## 15.7 Radioactive Release from Subsystems and Components

The information in this section of the reference ABWR DCD, including all subsections, figures and tables, is incorporated by reference with the following departure and supplements.

Figure 15.7-2 Offgas System (See Subsection 11.3)

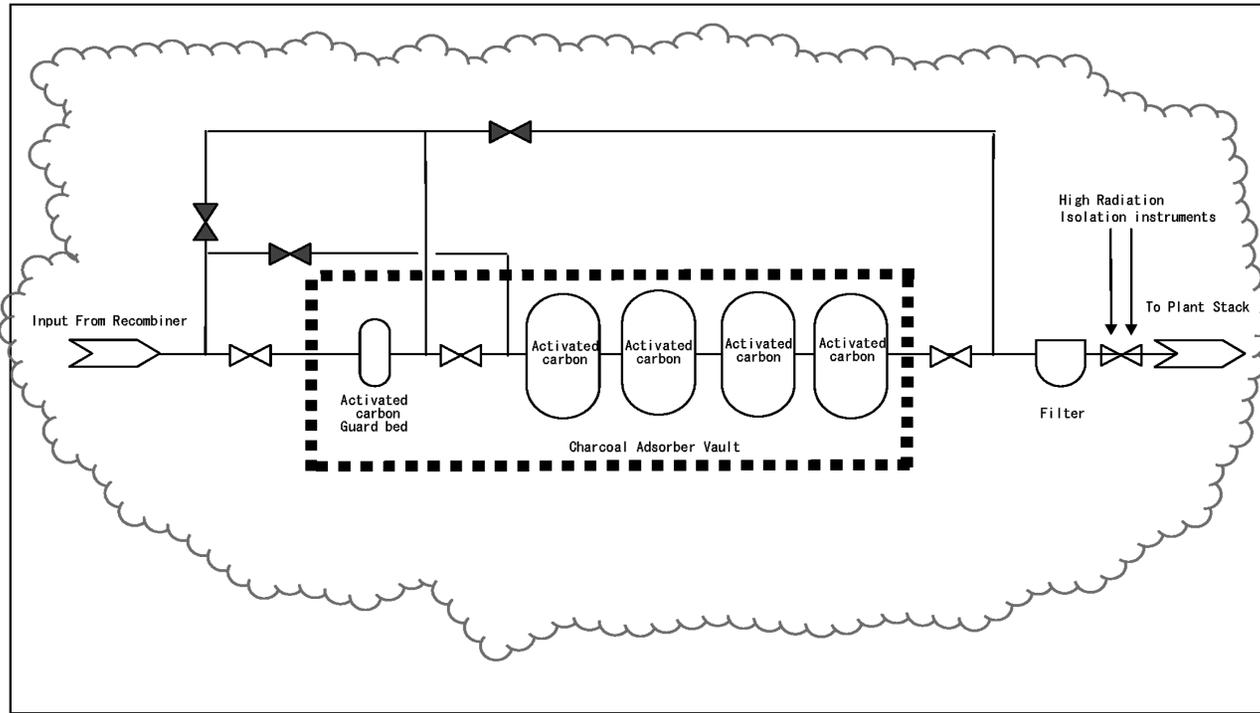
STD DEP 11.3-1 (Figure 15.7-2)

*To evaluate the potential radiological consequences of an inadvertent bypass of the charcoal beds, it was assumed that operator error or computer error has led to the bypass of the ~~eight~~four follow-on beds in addition to the failure of the automated air operated downstream isolation valve. It is also assumed that during this period, the plant is running at and continues to run at the maximum permissible offgas rate of 14.8 GBq/s (based upon the assumption of 0.0037 GBq/s/MWt as stipulated in Standard Review Plan 11.3) evaluated to a decay time of 30 minutes from the vessel exit nozzle. Even with the failure of the downstream isolation valve, it is not*

- (1) Flow is through a single 4,721 kg charcoal tank with an evaluated hold up time given by NUREG-0016, equation 1.5.1.6 using  $K_d$ 's for Kr and Xe from NUREG-0016.
- (2) ~~An isolation valve prevents flow through the~~ ~~There is no motive force to remove any significant inventory from the~~ eight follow-on charcoal tanks while in bypass and therefore no activity from these tanks is included in the final release calculations.
